Technical Service Information

FORD 5R55W/S TICKING OR RATTLING NOISE FROM BELLHOUSING

Figure 1

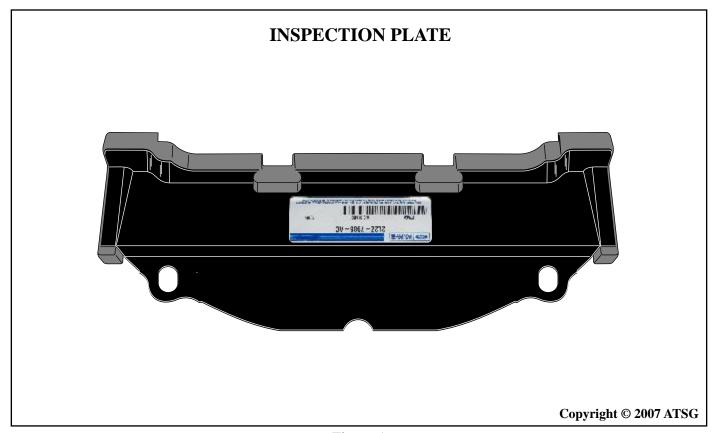
CAUSE: The cause may be, the plate between the engine block and the bellhousing is flexing, with

increased engine rpm, causing the noise.

CORRECTION: Ford Motor Company has released a new style inspection plate, which is located at the bottom of the bellhousing, that has foam rubber to insulate the plate between the engine and

transmission to keep it from flexing. Replace the inspection plate with new design as shown

in Figure 1.

INSPECTION PLATE......2L2Z-7986-AC
